Work Order ID 78861

Item Name: Crosstube Fwd

DRAWING NO. D206-667-141	TITLE CROSSTUBE ASS'Y (206B HIGH FWD)	REV. C	DART AEROSPACE LTD ENGINEERING ORDER		D.E.O. NO. D206-667-141-C-1	SHEET NO. SHEET 1 OF 1	SCALE NTS
DRAWN <i>q</i>	CHECKED <i>ASS</i>	MFG. APPR. <i>AD</i>	APPROVED <i>MD</i>		DE APPR. <i>HA</i>		
DATE 11.07.15	DATE 11.07.20	DATE 11.07.21	DATE 11/07/21		DATE 11.07.21

DART SERVICE INSTRUCTION

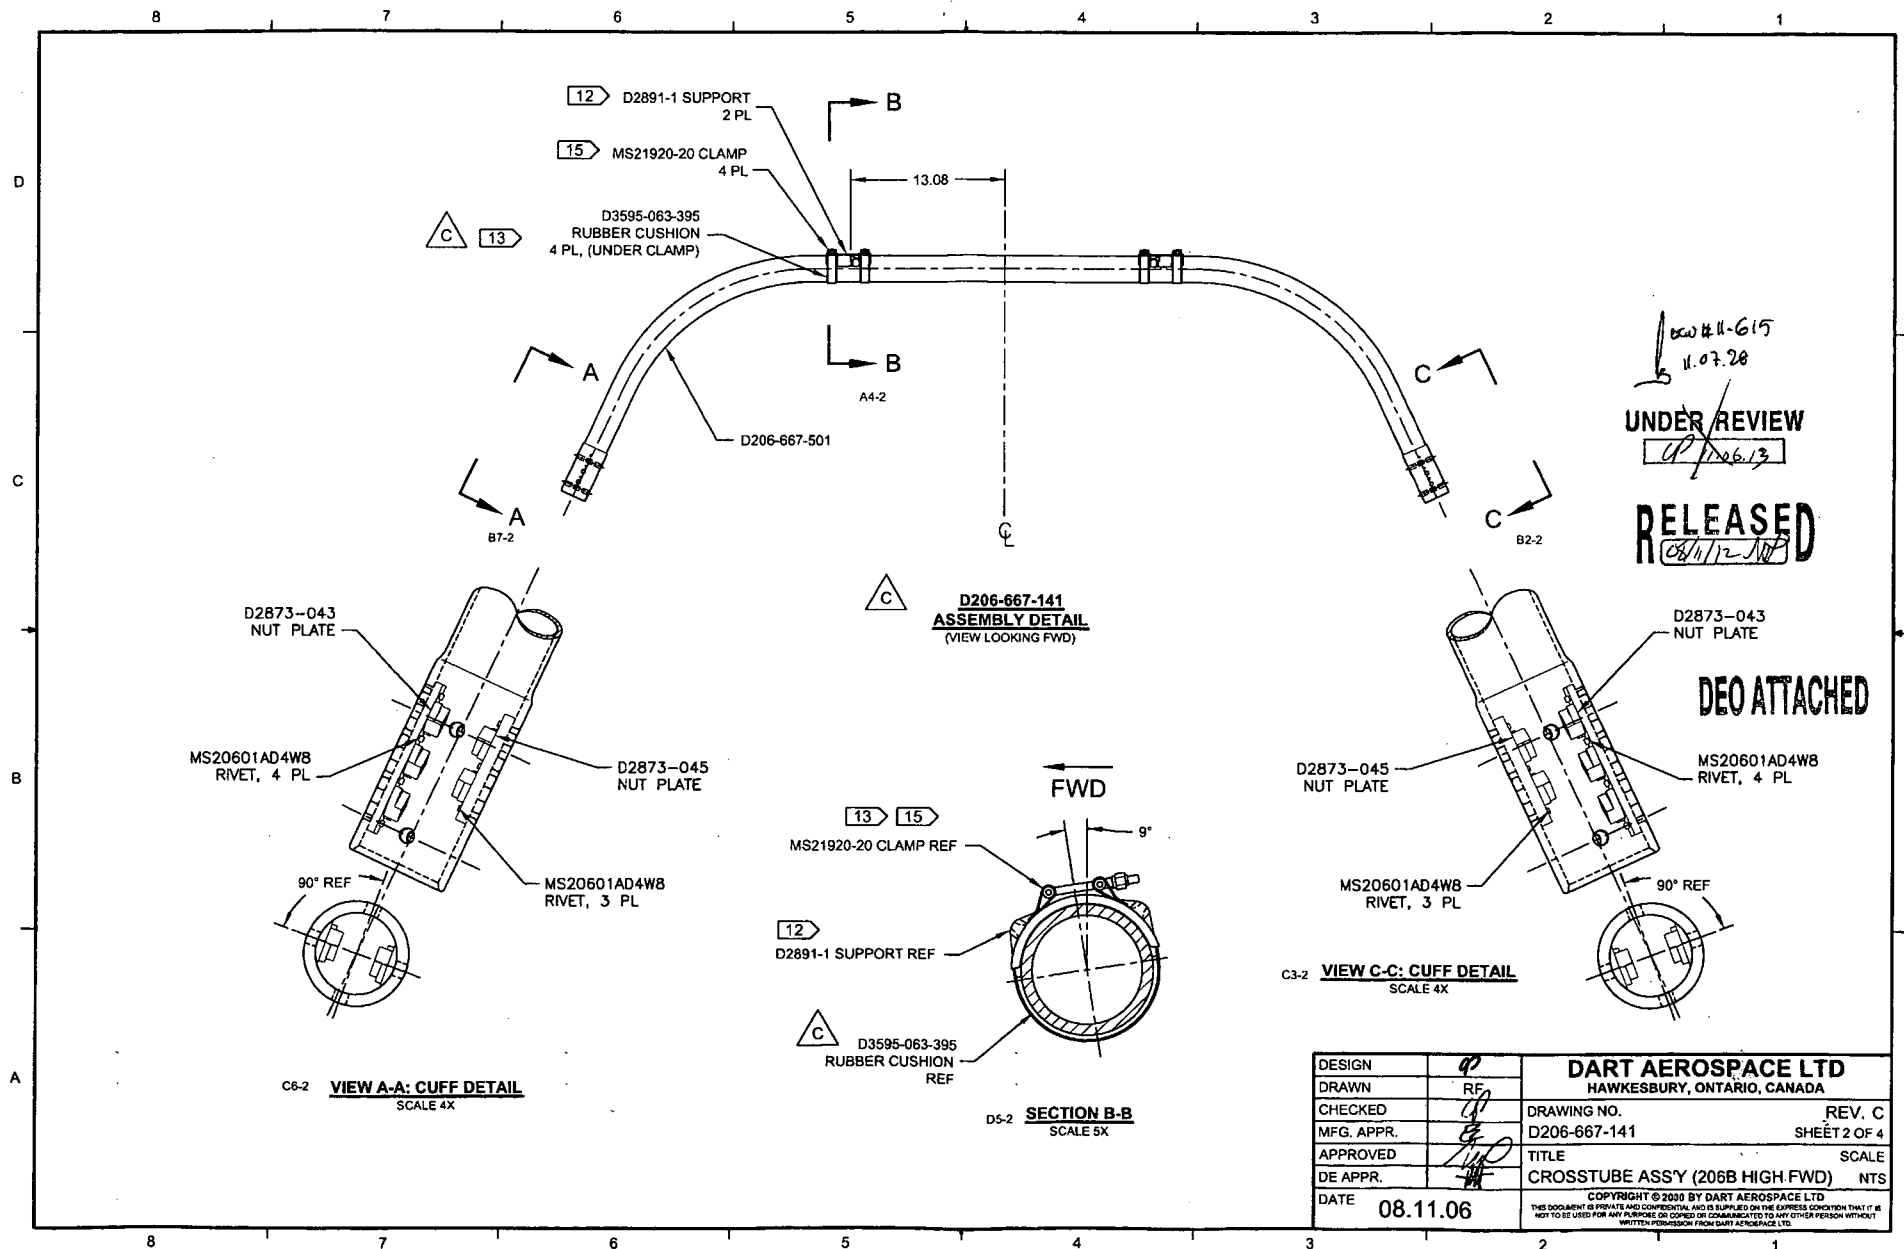
C	REVISE GENERAL NOTES/PART LIST (ZN D7-1); REORGANIZED VIEWS AND REFORMATTED DRAWING TO CURRENT STANDARDS. D3595-063-395 WAS D2856-400-894 (ZN D6-2 & A5-2); REMOVED REF. & ADD TOLERANCES (ZN C4-3, C5-3 & D3-3); RELOCATED FLAG #6 (ZN A5-3) PER NCR 210; MOVED TURNING DETAIL & UPDATED TOLERANCE TO SHEET 4.	RF	08.11.06
B	ADD HOLES AND NUT PLATES FOR COMPATABILITY WITH BHT/AA SKUDTUBES	PH	05.07.26
A	NEW ISSUE	CP	00.11.17
REV.	DESCRIPTION	BY	DATE
DESIGN	RF	DART AEROSPACE LTD HAWKESBURY, ONTARIO, CANADA	
DRAWN	RF	DRAWING NO. REV. C D206-667-141 SHEET 1 OF 4	
CHECKED	RF	TITLE SCALE CROSSTUBE ASS'Y (206B HIGH FWD) NTS	
MFG. APPR.	RF	COPYRIGHT © 2006 BY DART AEROSPACE LTD THIS DOCUMENT IS PRIVATE AND CONFIDENTIAL AND IS SUPPLIED ON THE EXPRESS CONDITION THAT IT IS NOT TO BE USED FOR ANY PURPOSE OR COPIED OR COMMUNICATED TO ANY OTHER PERSON WITHOUT WRITTEN PERMISSION FROM DART AEROSPACE LTD.	
DE APPR.	RF	DATE 08.11.06
